# MANUAL CHANGES

Model Number: 8445B  
Date Printed: May 1973  
Part Number: 08445-90103

This supplement contains important information for correcting manual errors and for adapting the manual to instruments containing improvements made after the printing of the manual.

Figure 1. Partial Schematic of Figure 8-10

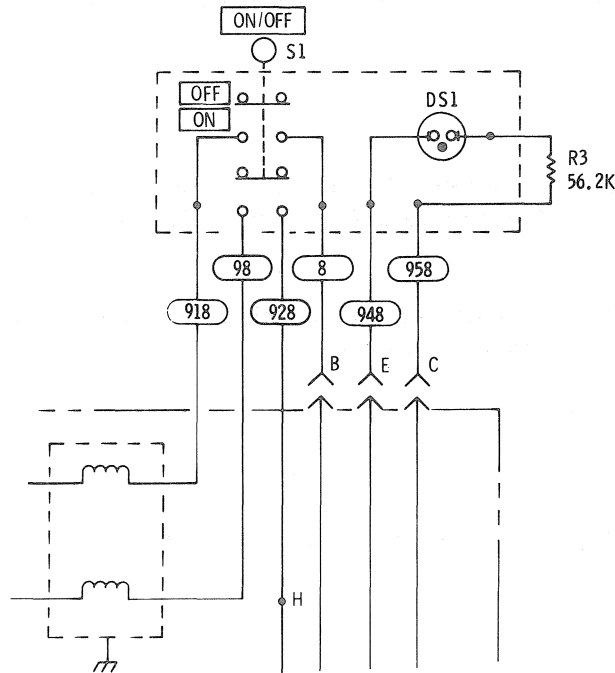
Page 8-23, Figure 8-10 (Service Sheet 6):

Change the diagram as shown in the partial schematic of Figure 1.

Figure 2. Partial Schematic of Figure 8-9.

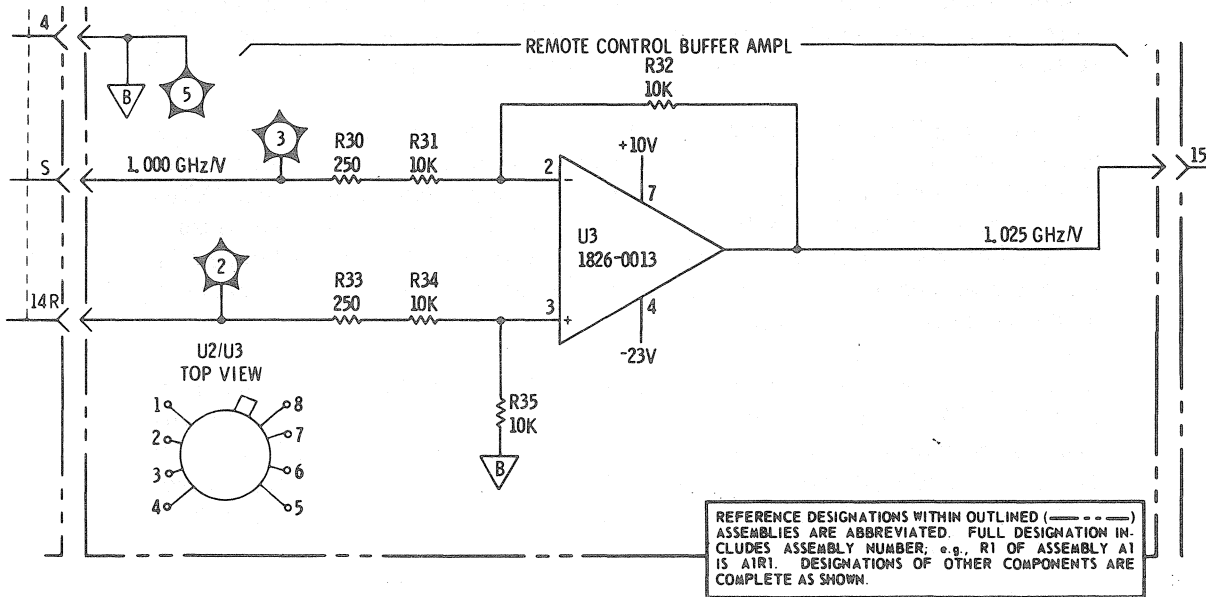
Page 8-9, Figure 8-21 (Service Sheet 5):

Change the circuit diagram as shown in the partial schematic Figure 2.

Figure 3. Partial Schematic of Figure 8-8.

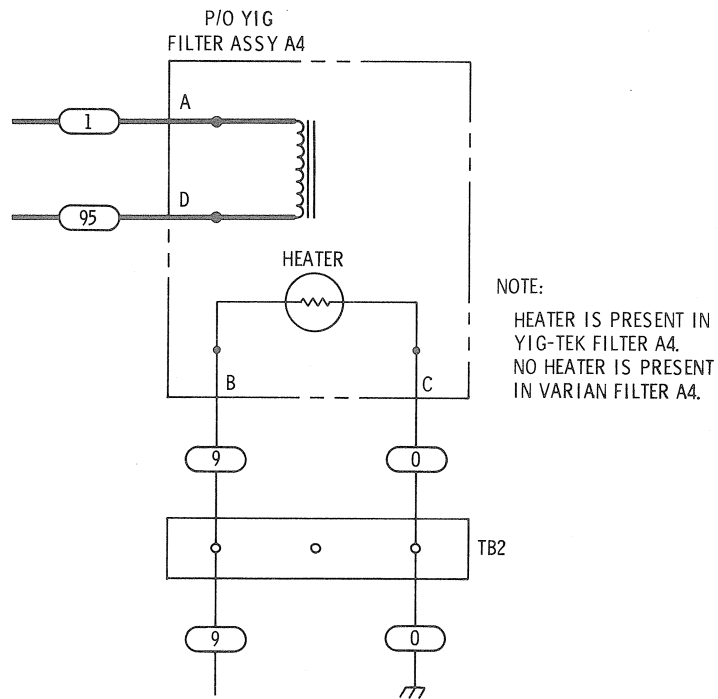
Page 8-19, Figure 8-8 (Service Sheet 4)

Add terminal strip TB2 as shown in partial schematic Figure 3.
